Commercial Pre-Application Meetings May 12, 2021

The Overlook at Turnbull Bay (10 acres with the golf course east and west of it and off the northern extension of Osprey Cove Dr.) Developers were back, taking the suggestions from the [April 2021](#) Pre-app meeting and presenting what they had done on a new Concept Plan. The new subdivision proposes 25 single-family homes on 60' wide lots with 7.5' side setbacks. Overall, City staff felt that this plan was better than the previous one, and the residences will sell due to their price point and location.

**OVERLOOK AT TURNBULL BAY
 CONCEPT PLAN
 SITE PLAN**

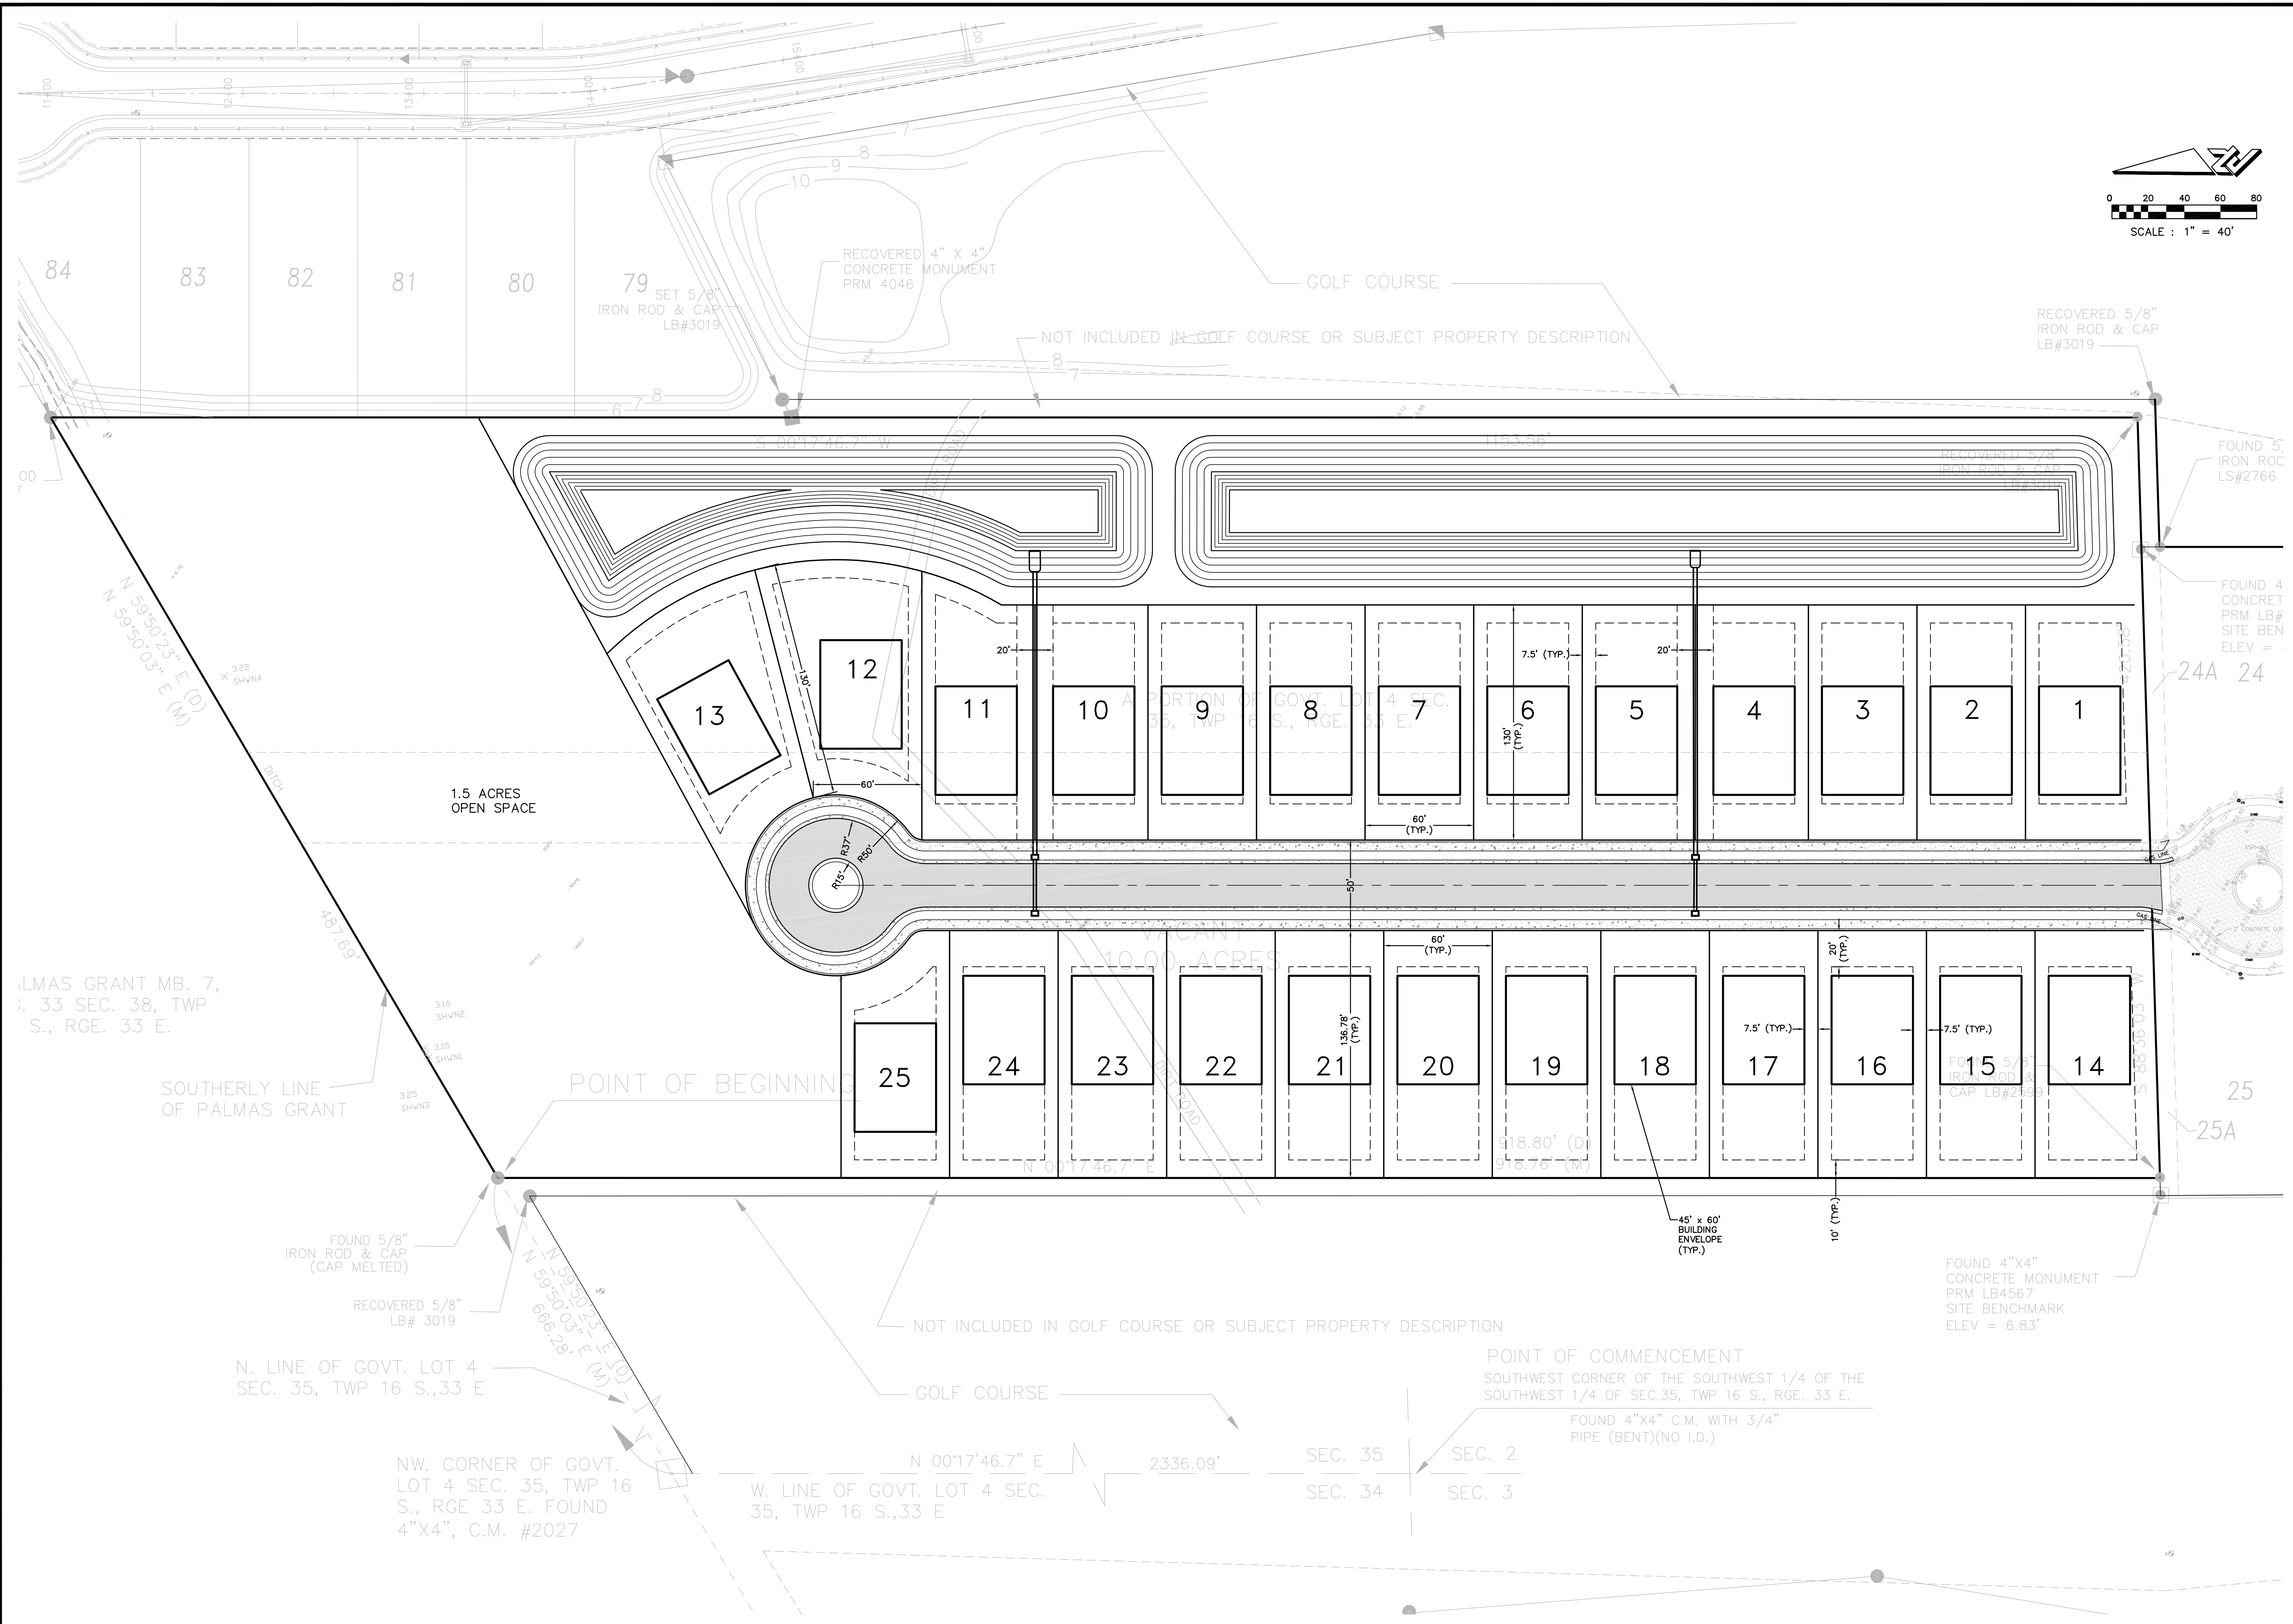
- There was still a question about the length of the cul-de-sac. Our LDR states that it shall not exceed 1,000' in length, "unless necessitated by topographic or environmental constraints" which there may be once the parcel is formally platted. Staff will review this in detail when the Site Plans are submitted to determine if this criterion applies.

- There was still a concern about no secondary access but since the development hit the threshold of 25 units, it will pass.
- The 50' wide public access easement that was done in '98 may need to be removed; however, it looks like it could be a problem, for the State owns it, but the County may oversee it. More research will be needed.

- The new wetlands, flood plains, and tree regulations will need to be followed although none seemed to be a problem as the plans either were or will be adjusted to them.

- There is a dirt road that bisects the parcel that may need to be dealt with depending upon ownership.
- MDA will need to be modified as it expired, but it looks like most everything is covered but may need an endangered species study as well as have the conservation areas.

- It was suggested to make a crosswalk sidewalk at the bulb of the cul-de-sac.

- The cul-de-sac will be ok as long as its radius is 45' for turning.
- The location of hydrants will need to be shown on the Site Plan.
- Street parking cannot hinder the 24' width needed for ER/firetruck vehicles.

- Note retention ponds for stormwater; outfall will run into a ditch and into Turnbull Bay.

- Electric will need to be consistent with the other subdivisions, so it can be looped.
